ADDENDUM 1 – JOB 28

TO: All prospective bidders on project NHU-4-002(116)149, Job No. 28 scheduled for the November 17, 2017 bid opening.

ADDENDUM 1 - JOB 28

Addendum 1 is to address: Addition of a sanitary sewer service and a water service to be stubbed in at the property of Frank Bader along the north side of 14th Ave SE. Revising the location of the southerly temporary access to Gooseneck Implement Company's property on the west side of US Highway 2 and adding a permanent driveway in the same location.

Revised	9/27/2017	STATE	PROJECT NO.	SECTION NO.	SHEET NO.	
		ND	NHU-4-002(116)149	2	1

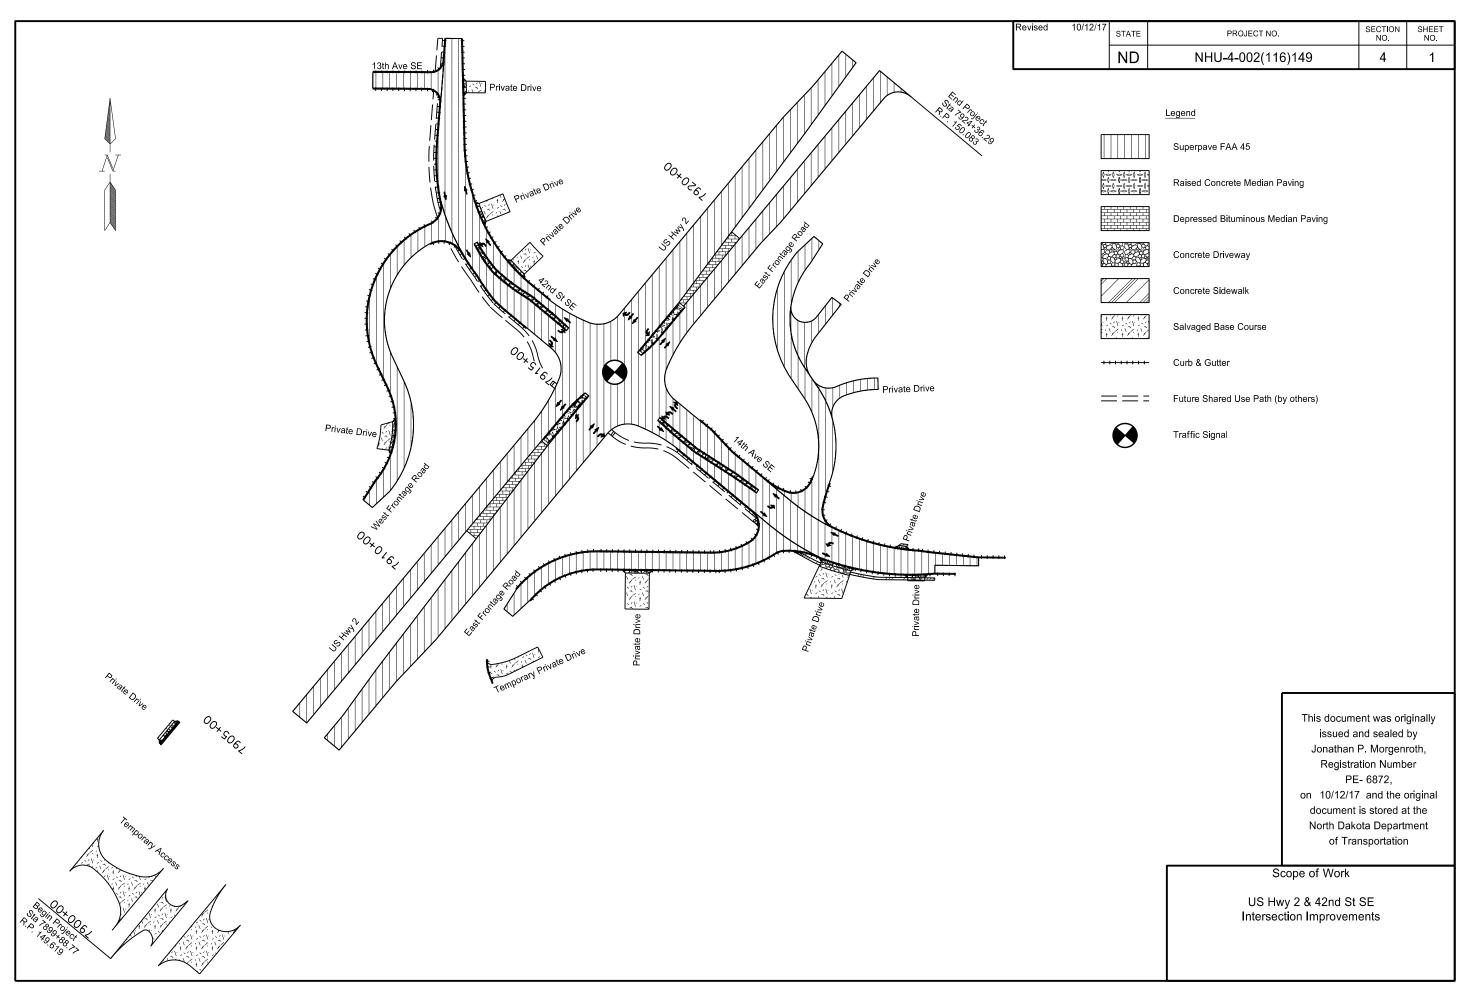
Sheet 2-1:

Added sheet 20-11.

Revised	10/11/17	STATE	PROJECT NO.	SECTION NO.	SHEET NO.
		ND	NHU-4-002(116)149	20	10

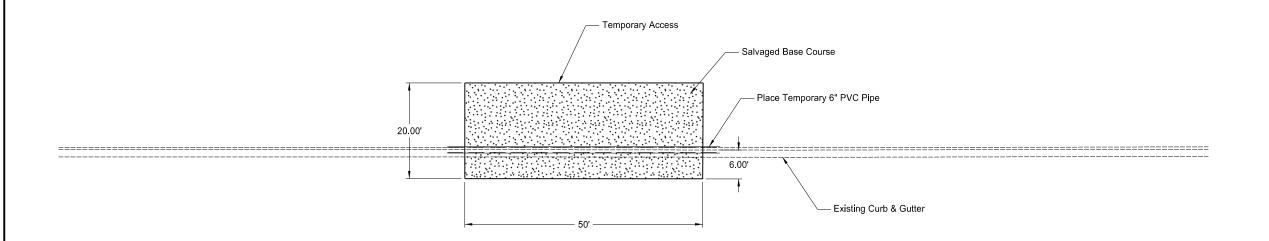
Sheet 20-10:

Revised size and dimensions of temporary access. Updated stationing.

Added	09/27/17	STATE	PROJECT NO.	SECTION NO.	SHEET NO.
		ND	NHU-4-002(116)149	20	11

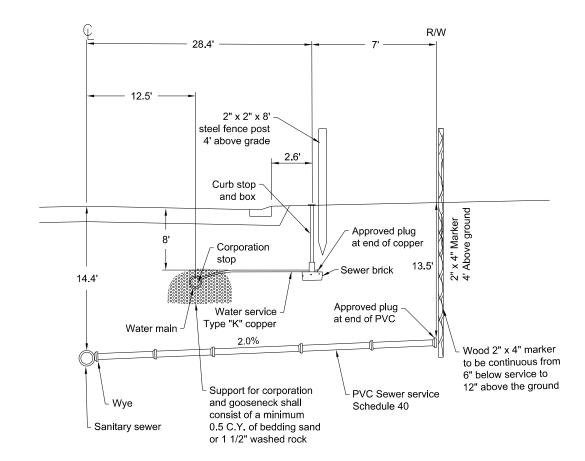
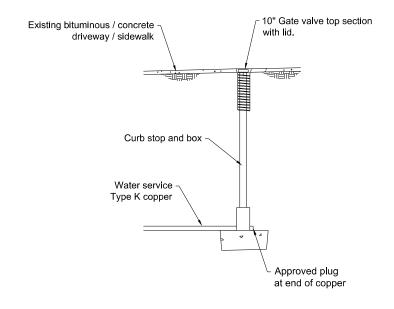
Sheet 20-11:

Added sheets to describe City of Minot residential service connection details.
